# Service Bulletin: SB 101

**GAME:** Circus Voltaire (1st 200 samples)

**SUBJECT:** Disappearing Jet Bumper assembly not releasing.

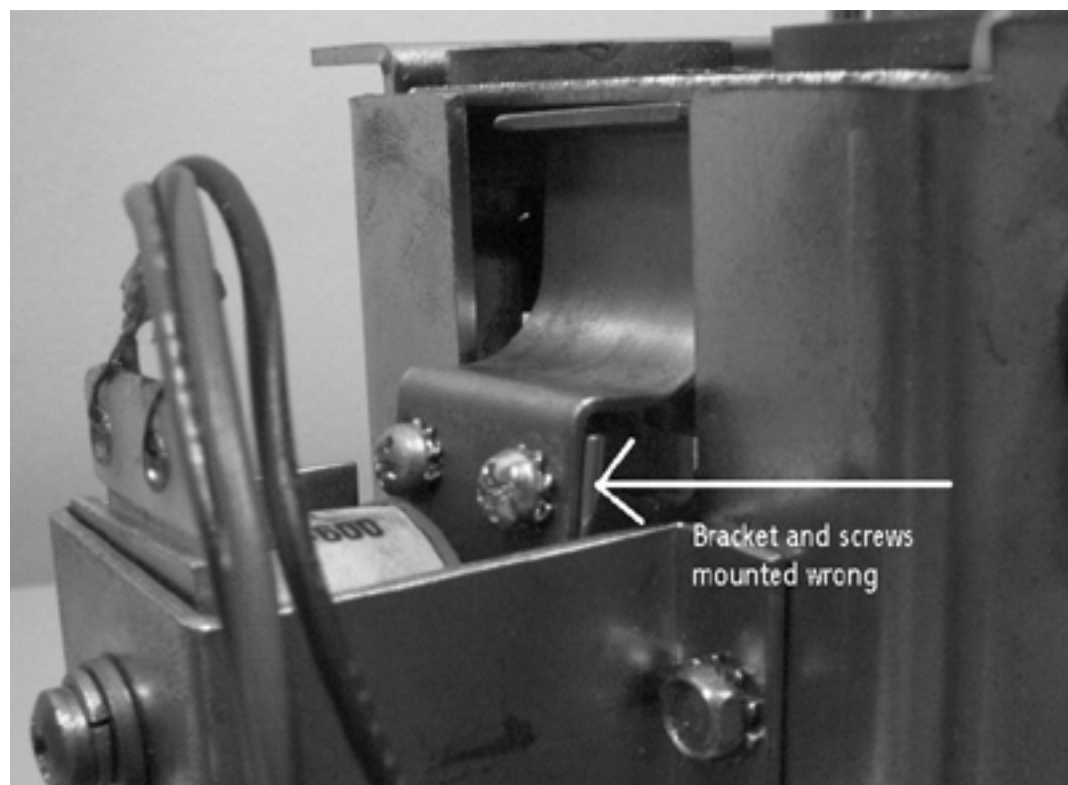
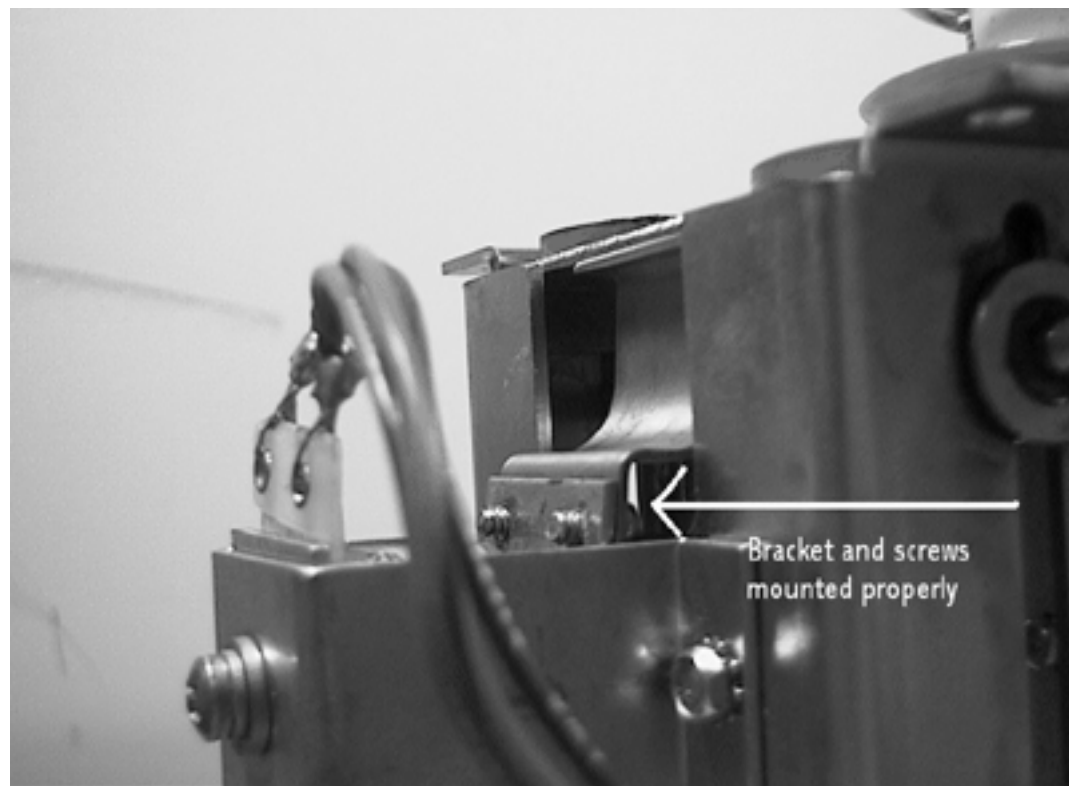
During our Quality Assurance testing we found that the brass latch which releases the disappearing jet bumper was installed incorrectly. Quality also found that the release coil frame was bending down. Both of these problems can affect the reliability of the jet bumper to drop. The 2 pictures below show the right and wrong way that the latch should be mounted. The bottom picture shows the bracket (Part #01-14803) that has been added to prevent the coil frame from bending.

Picture above shows the latch mounted incorrectly.

Picture above shows the latch mounted correctly.

Part #01-14803 prevents the coil frame from bending.
